MEETING:	PLANNING AND REGULATORY COMMITTEE
DATE:	30 JULY 2025
TITLE OF REPORT:	251273 - PROPOSED FLOOD ALLEVIATION SCHEME TO ADDRESS HISTORIC FLOODING ACROSS THE MERTON MEADOWS AREA OF THE CITY AT CAR PARK (PLOT 1A & 1B) TOGETHER WITH PLOTS 4 & 5, EAST OF WIDEMARSH STREET, HEREFORD, HEREFORDSHIRE, HR4 9JU. For: Mr Holland per Ms Lucy Brackenbury, 41 Bengal Street, Ancoats, Manchester, M4 6AF
WEBSITE LINK:	https://www.herefordshire.gov.uk/info/200142/planning_services/planning_application_search/details?id=251273&search-term=251273
Reason Application submitted to Committee - Council Owned land and application

Date Received: 25 April 2025

Figure 1: Environment Agency Flood Map for Planning (Rivers and Sea), June 2025

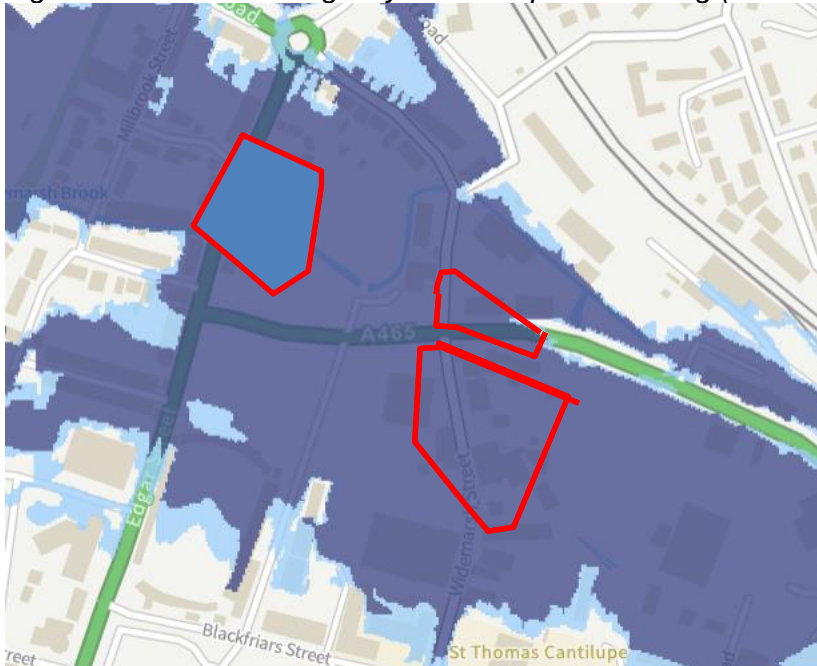
Review of the Environment Agency's Flood Map for Planning (Figure 1) indicates that the site is located within the high probability Flood Zone 2 and 3.

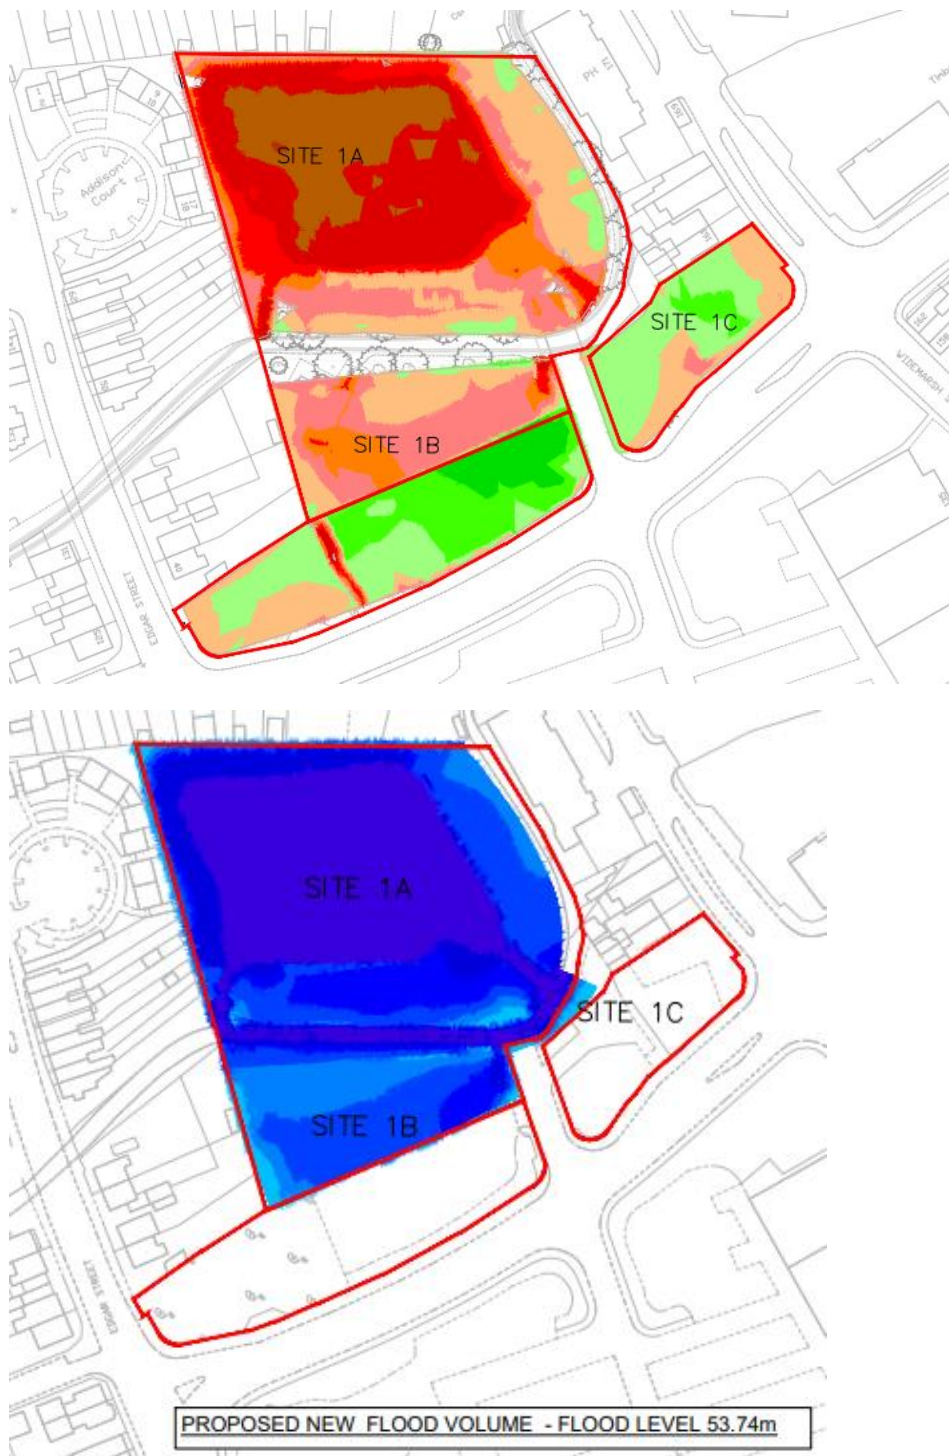
The model report advises that a western area of Plot 1B is to be raised to reduce flood risk to third parties

As explained above, the model that has been presented may not be an adequate tool for the purposes of setting property floor levels.

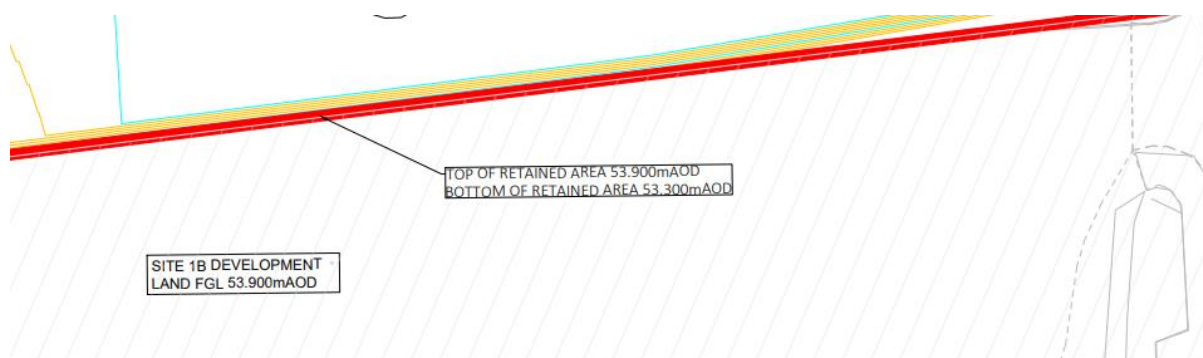
We note that the Cut & Fill drawing for Plots 1A,1B,1C shows works outside of the red line boundary, which are not referenced elsewhere in the planning application. These are the areas that have been highlighted in green (spoil is shown stockpiled).

Furthermore the Proposed Contours plan for sites 1A 1B 1C includes proposed Finished Ground Levels for these plots (1B and 1C - 153.90m). The drawing suggests that there will be a retaining feature to hold the fill up.
